**STATE OF CALIFORNIA  
CALIFORNIA REGIONAL WATER QUALITY CONTROL BOARD  
CENTRAL COAST REGION**

**STAFF REPORT FOR REGULAR MEETING OF JULY 12, 2012**  
Prepared June 11, 2012

**SUBJECT:** Reissuance of General Conditional Waiver of Waste Discharge Requirements for Timber Harvest Activities in the Central Coast Region (Timber Order) Order No. R3-2012-0008

Figure 1. Existing Monitoring Tier Determination (Example)

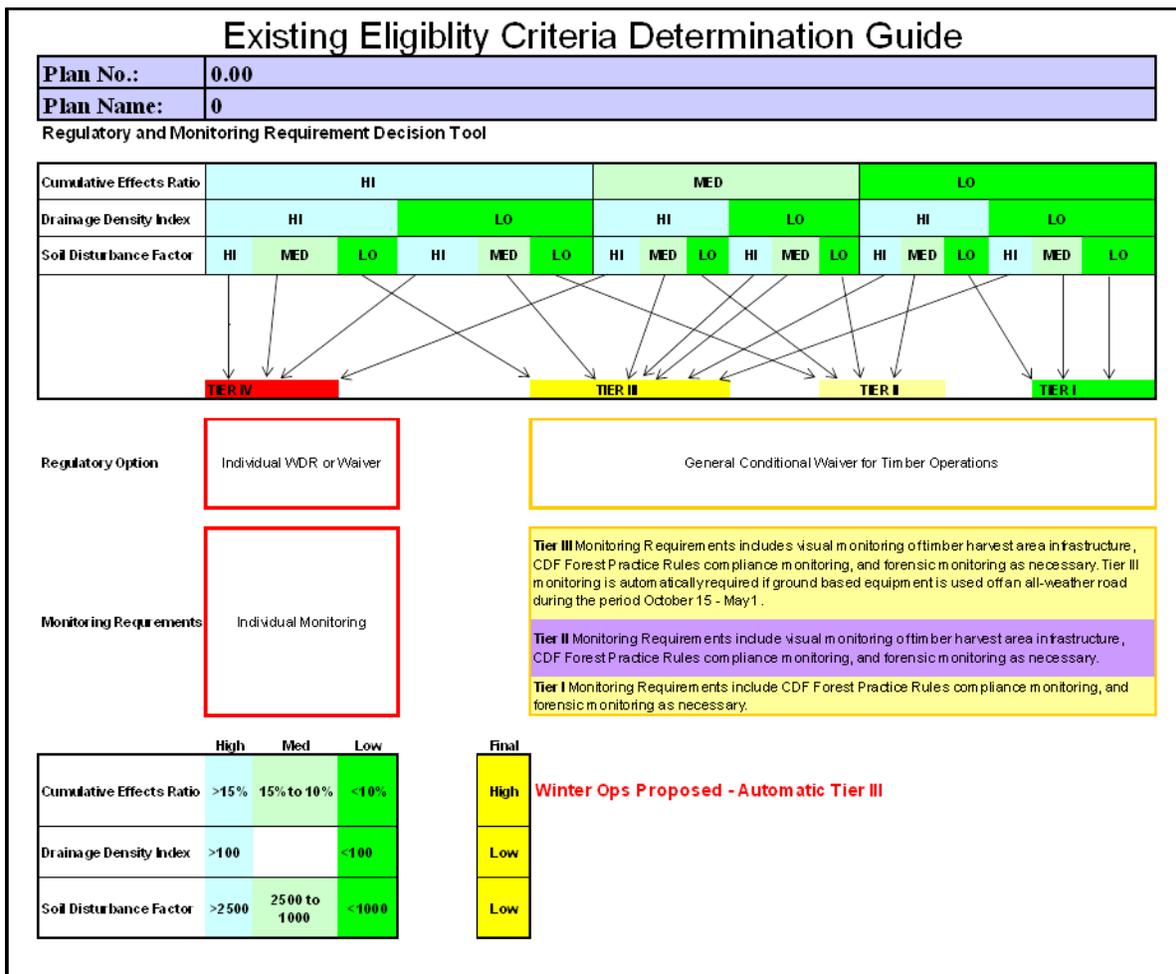
- If a THP proposes winter operations, the existing EC automatically assigns it to Tier III, and
- The hierarchical structure of the existing tier determination (Figure 1, Appendix C) assigns a disproportionate weight to the CER and Drainage Density Index (DDI) before the EC considers the Soil Disturbance Factor (SDF).

Therefore, Water Board staff revised the EC to incorporate winter operations into the CER as a proportional factor, wherein it is considered but not given absolute authority to decide the tier ranking. While this changes the weight winter operations is given in the EC computation, the approach recognizes that winter operations vary widely in scope and should not be the sole basis to rank a THP as Tier III. Staff review of winter operation plans will continue to be focused priority for staff inspections.

Figure 8. Planning watershed coverage of Slope Class GIS file.

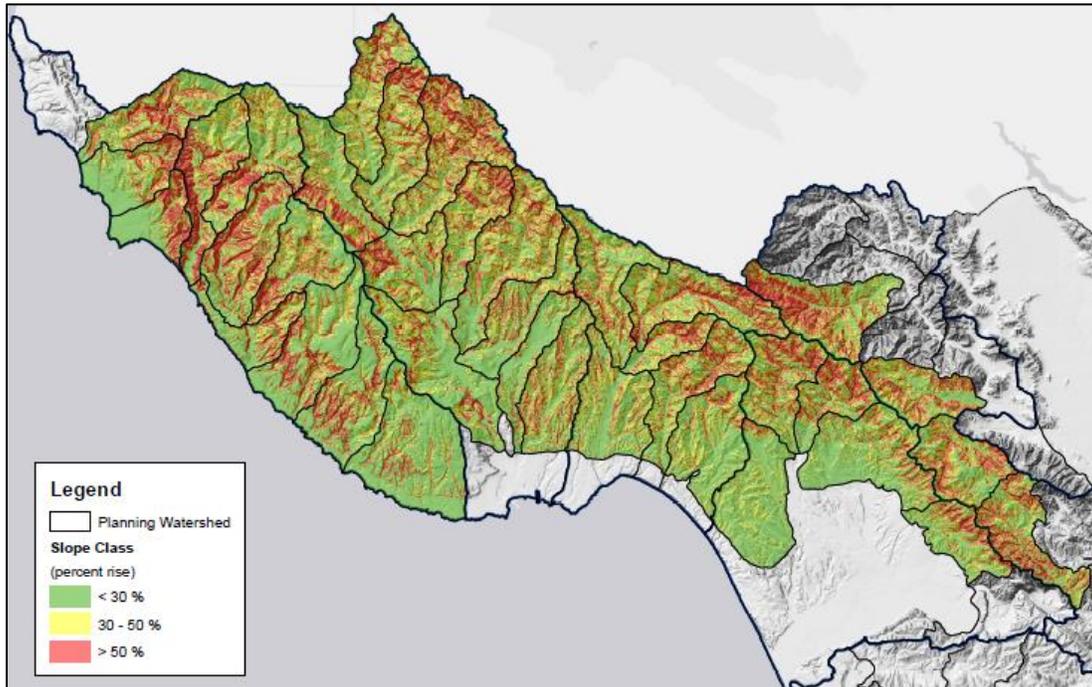
18. The new proposed side-slope analysis is complicated, arbitrary, and will provide no direct benefit to water quality assessment.

Staff Response: The side-slope analysis in the proposed Drainage Density Index (DDI) is based on measurable factors, principally the areal extent of watercourse protection zones as determined by the side slope. The measurements provide a proportional and objective measure of the general risk to water quality. Staff analysis of the previous DDI revealed the multipliers used failed to adequately capture the known risk to water quality from class II and class III streams (i.e. low order streams). The method employed in the proposed DDI is founded on a conceptual model framework. The revised statistical Tier determination method relies on the performance of the DDI as designed. Water Board staff has prepared the necessary GIS slope class files to assist Dischargers in calculating their plan's watercourse protection zone area and provide an alternative method for Dischargers who do not possess the necessary GIS capabilities. Both proposed methods for calculating the DDI rely on discrete objective measurements instead of arbitrary and unsupported multipliers.
